**Table A1.2**      **Technical Stakeholder Comments**

Topic	Comment	RHDHV Response	Follow up required?
<b>Workshop 1: Physical environment – coastal processes</b>			
1.1	What is the plan for commencing the build of the Breakwater, are you going to start from the North East side or both ends of it and meet in the middle?	The design team will be working on that and the approach has not been finalised as yet.	No

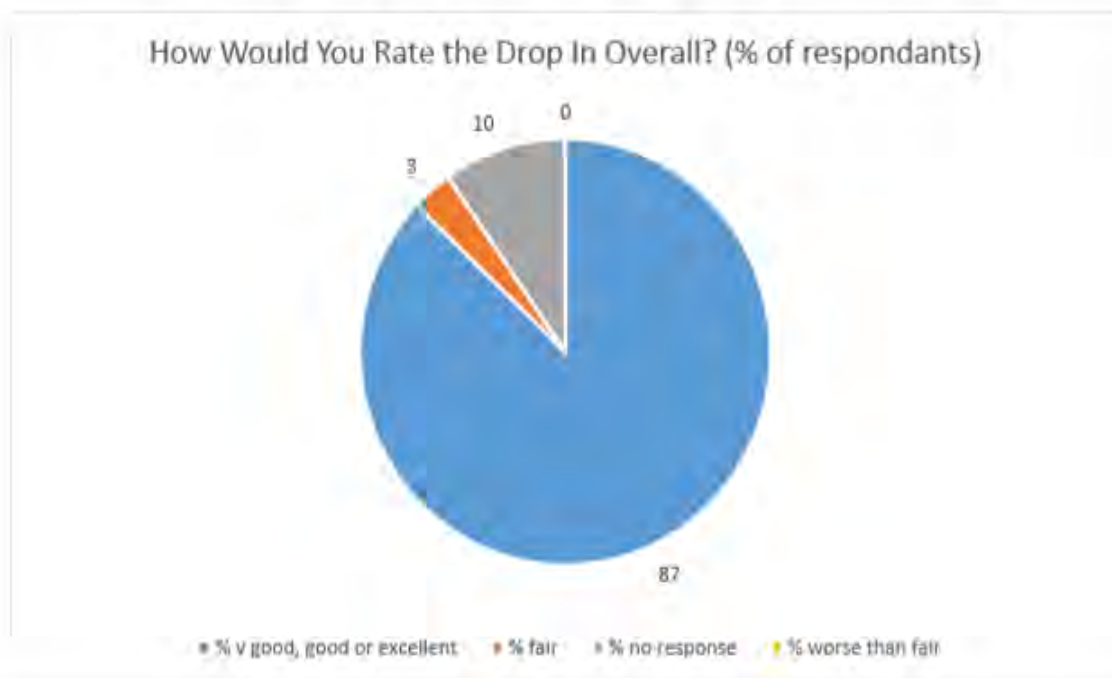
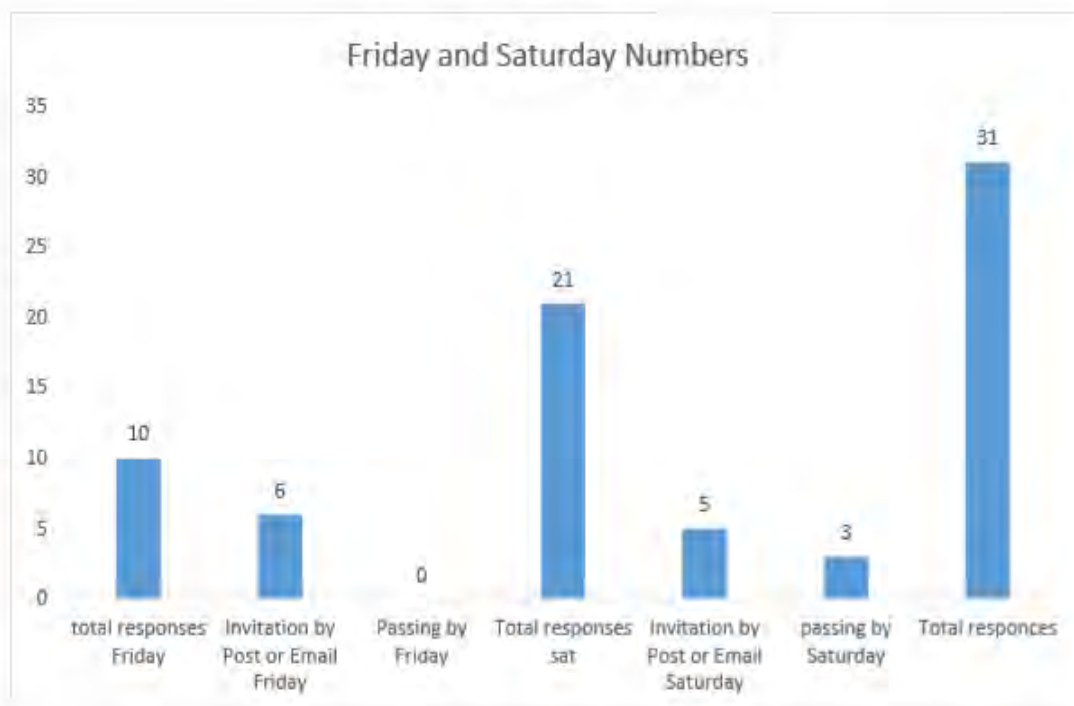
05-04-19	Project Design	The amount of Harbour space that could be taken up during a potential operational phase of an inert waste disposal facility if it were to be located East of the QEII is dependent on the design and purpose of the fill area. Considering	<p>The Project proposed is the Longue Hougue South site which is detailed in <b>Chapter 4 Project Description</b>. The selection of the site is detailed in <b>Chapter 3 Site Selection and Consideration of Alternatives</b>.</p>

Date	Topic	Comment	RHDHV Response
		past experience with the existing site, there should not be too much impact, and that could potentially be mitigated. A bigger issue would be accessing the site for construction of the rock armour breakwater if this was done from the landward side rather than the sea – the logical starting point for this would appear to be from the northern most point of the QEII breakwater, with access along the breakwater. We would also need to consider operationally how the site would be filled initially – I think the logical method would be to cut through the raised breakwater at the end of the access road once the new breakwater is in place and fill from there. This would need a turning area for vehicles, but not a lot else if bulking continued at Longue Hougue.	The approach to construction of the breakwater at Longue Hougue South is described in <b>Section 4.4</b> , two options are possible and the worst-case scenario of either option was assessed throughout the technical chapters. Infilling operations are described in <b>Section 4.5</b> and shown on <b>Figure 4-4</b> . Access is through the same access as the Household Waste Recovery Centre with vehicles then travelling around the landward edge of Longue Hougue to access Longue Hougue South from the north-east corner. Infilling operations would then progress from east to west.
